RS11-001

2009 – 2010 G37 CONVERTIBLE; PRE-TENSIONER SEAT BELT RETRACTOR SERVICE INFORMATION

APPLIED VEHICLE: 2009 – 2010 G37 Convertible (HV36)

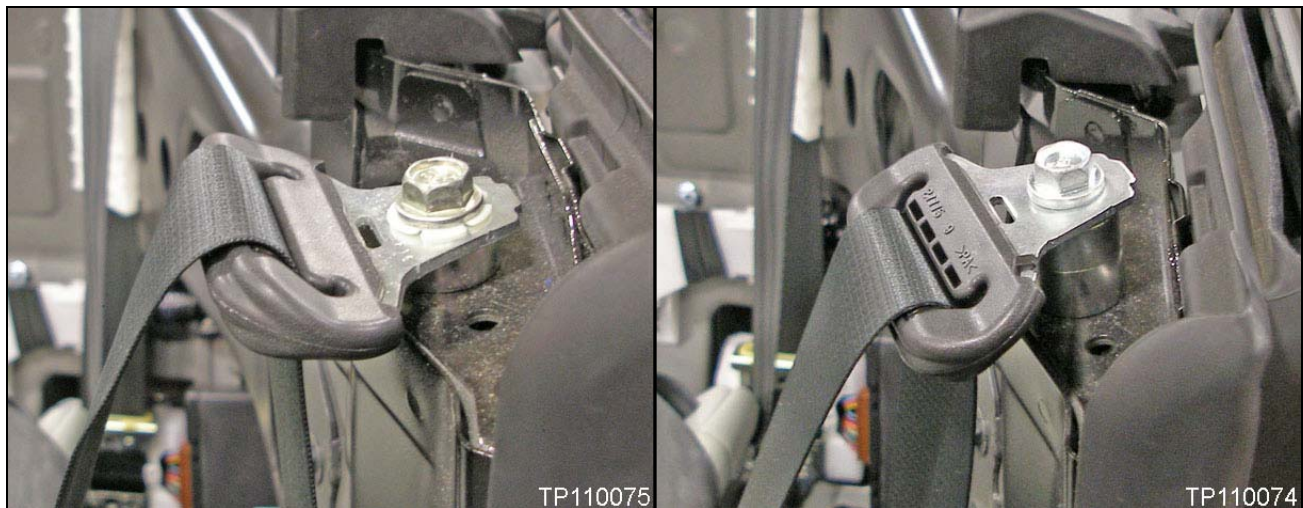
Replacement pre-tensioner seat belt retractors for 2009 – 2010 G37 Convertibles have been revised. The re-designed “D” ring is raised with a taller bolt and collar. When replacing a pre-tensioner seat belt retractor for any reason, adjustments for additional clearance will need to be made to the related rear side finisher.

See below for differences between previous and revised “D” rings, bolts, and collars.

Old style.

New style.

Rear side finisher.

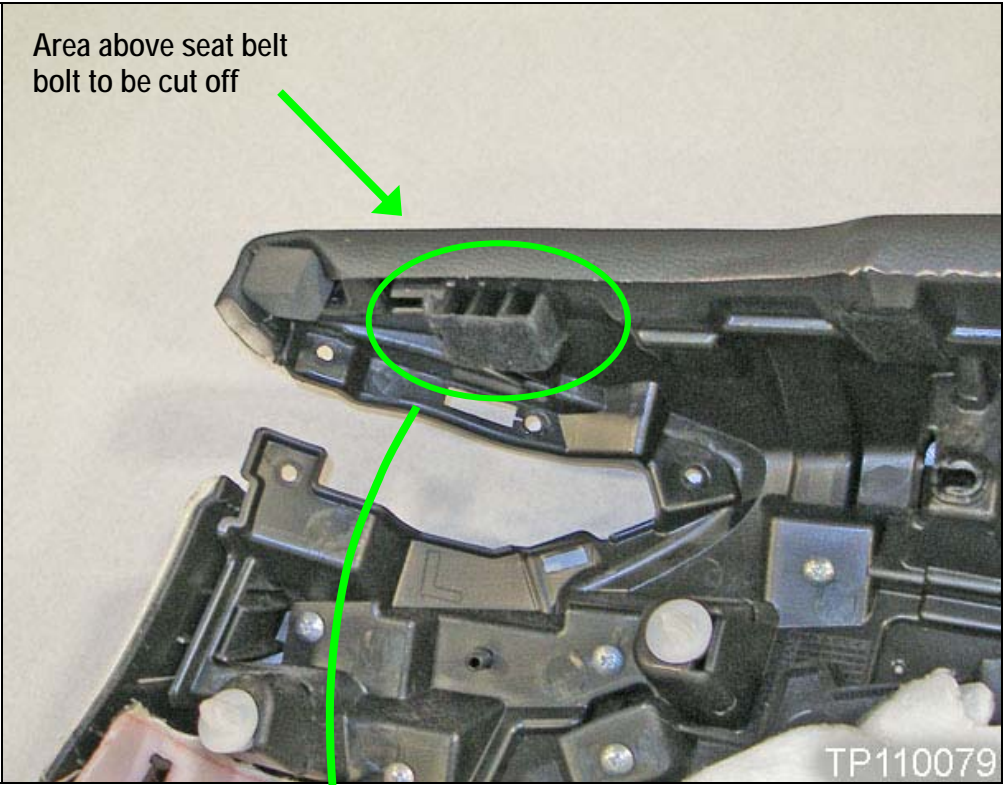
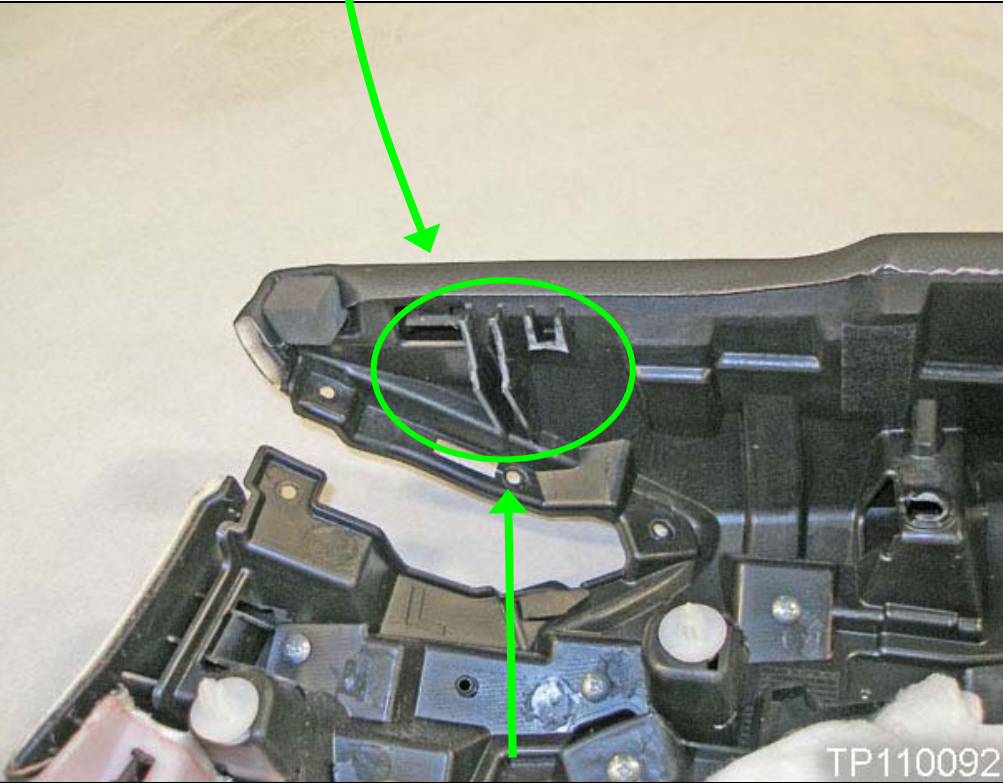
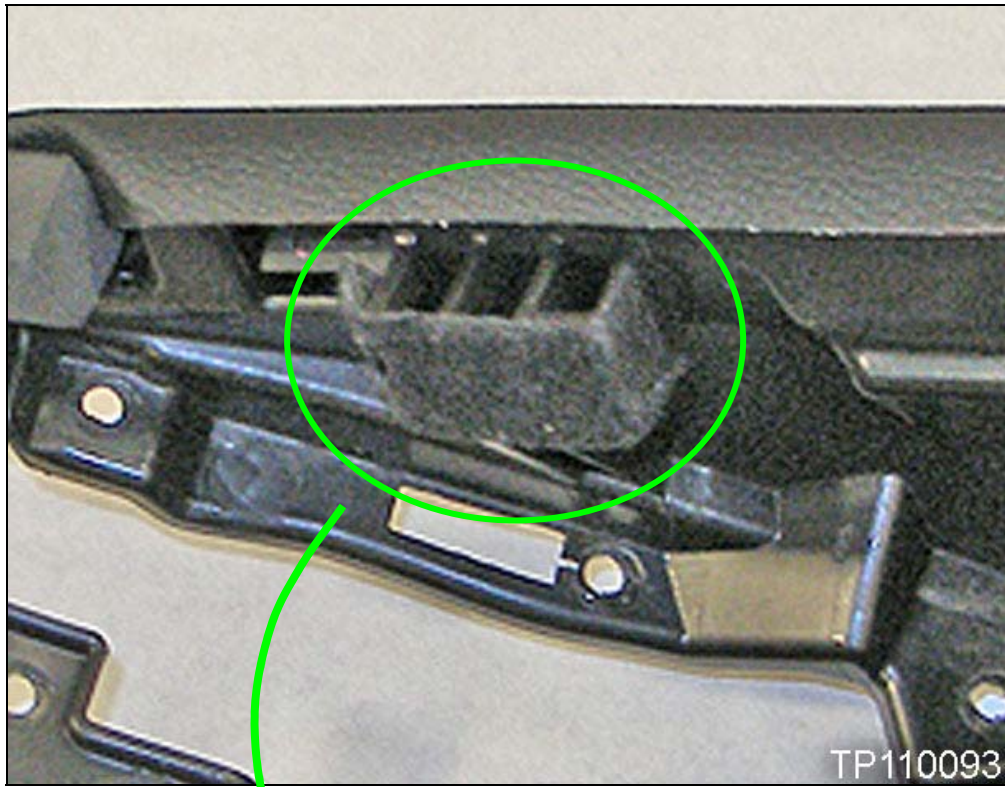
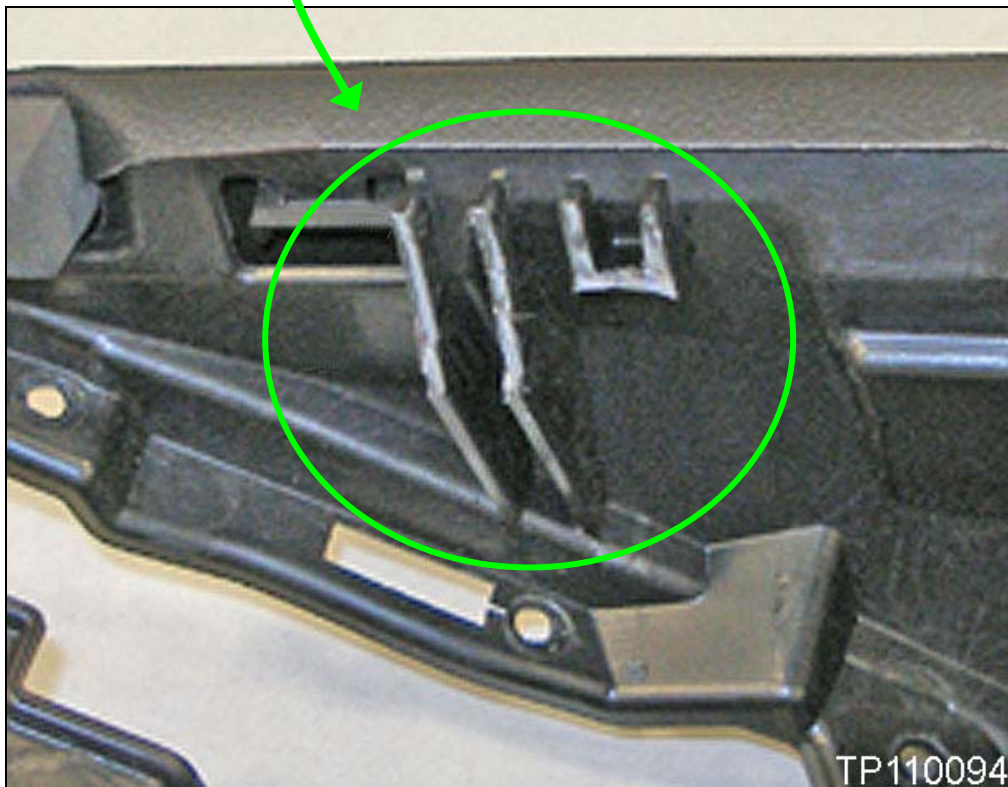
Go to Page 2 and 3 for rear side finisher adjustments.

Location of cut area.

Close-up of area to be cut.

Close-up of cut area.
